Deputation to the City of Melville

By Michelle & Victor Mews, 16th June 2020

WEST ELEVATION 6
SCALE 1:100 @ A1

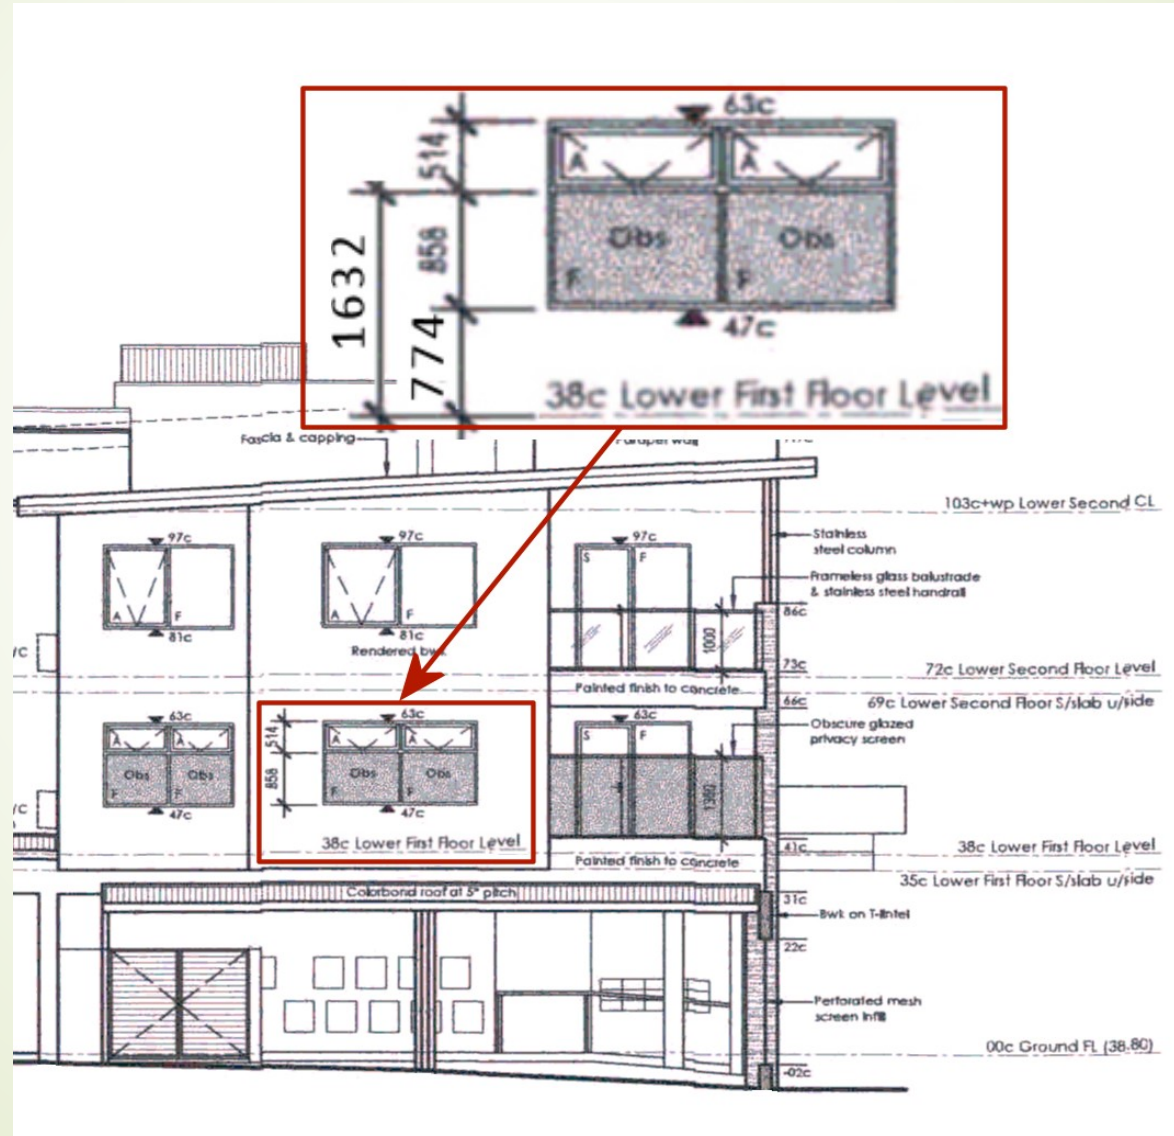
Condition 3 of Planning approval, DAU meeting 10 July 2018

Prior to the initial occupation of the development, the WESTERN elevation of Unit 1's Living, Meals and Balcony, and the WESTERN elevation of Unit 2's Meals and Kitchen (as marked in RED on the approved plans) shall have installed, fixed obscure screening to a minimum height of 1.6 metres above the finished floor level, or any other screening alternative that complies with the purpose and intent of C1.1 or C1.2 of Clause 6.4.1 of the Residential Design Codes. The screening measures must thereafter be retained in perpetuity to the ongoing satisfaction of the City.
